## DESC input to SCOC: June 10, 2022

# Validation of DESC MAF Metrics: June 10, 2022

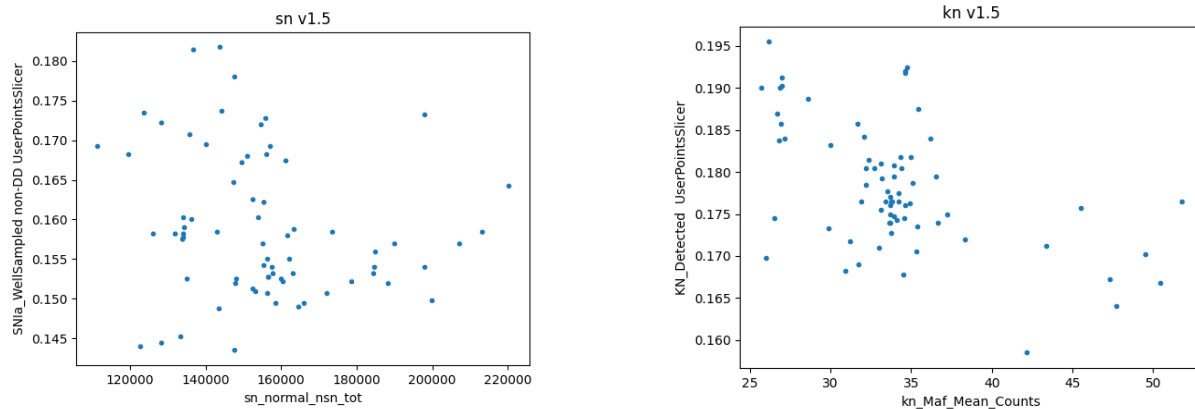
In the figures above, we compared the original DESC metrics for SN and KN (x-axis) against their MAF counterparts for v1.5 (y-axis). These MAF metrics were *not* the same implementation as the original ones (e.g. the SN Ia WellSampled metric is based on the PLAsTiCC data). However they are supposed to be measuring similar things (well-sampled SNe ready for cosmology and detection of GW170817-like KNe). **We do not yet know whether this undesired behavior is due to a bug or unintended assumption.**
